Access Compliance Report

Public Rights-of-Way

Intersection ID: 21517	Main Street: BELLECHASSE_ST	Cross Street: COTILLION_AV	Location: SW
ADA ID: 4F725BAAAD5E	Ramp Type: BlendTrans1	Initial Pass/Fail: Fail	Overall Compliance: No
			Severity Score: 21.25

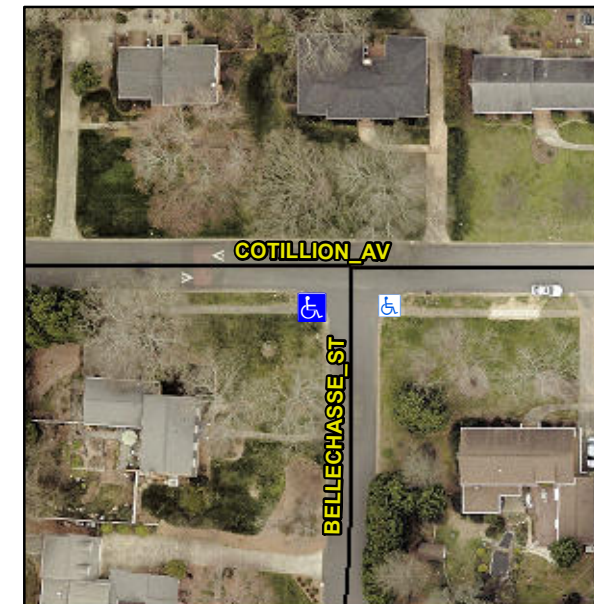
Not Found, R304.5.1, R304.5.3

Compliance	Description	Data	Compliance	Description	Data
N/A	Ramp Length (in)	57.0	Yes	BlendTrans Slope (%)	1.8
No	Ramp Width (in)	45.0	No	BlendTrans XSlope (%)	5.6
N/A	Flare Type LT	N/A	N/A	Flare Type RT	N/A
N/A	Flare Slope LT (%)	N/A	N/A	Flare Slope RT (%)	N/A
N/A	Flare Traversable LT?	N/A	N/A	Flare Traversable RT?	N/A
N/A	Landing Length (in)	N/A	N/A	DWS Provided?	N/A
N/A	Landing Width (in)	N/A	N/A	DWS Contrast?	N/A
N/A	Landing Slope (%)	N/A	N/A	DWS Length (in)	N/A
N/A	Landing X Slope (%)	N/A	N/A	DWS Full Width?	N/A
N/A	Landing Curb? (Y/N)	N/A	N/A	DWS Offset (in)	N/A
N/A	Shared Landing?	N/A			
N/A	Gutter Ponding?	N/A	N/A	Gutter Slope (%)	N/A
N/A	Gutter Lip Ht (in)	N/A	N/A	Gutter X Slope (%)	N/A
N/A	Painted X Walk1?	No	N/A	Painted X Walk2?	No
	X Walk 1 Direction	To E		X Walk 2 Direction	To N
	X Walk 1 Width (in)	N/A		X Walk 2 Width (in)	N/A
	X Walk 1 Slope (%)	6.3		X Walk 2 Slope (%)	0.9
	X Walk 1 X Slope (%)	0.3		X Walk 2 X Slope (%)	7.6

Remove & Replace Curb Ramp With Two New Directional Ramps or Equivalent.
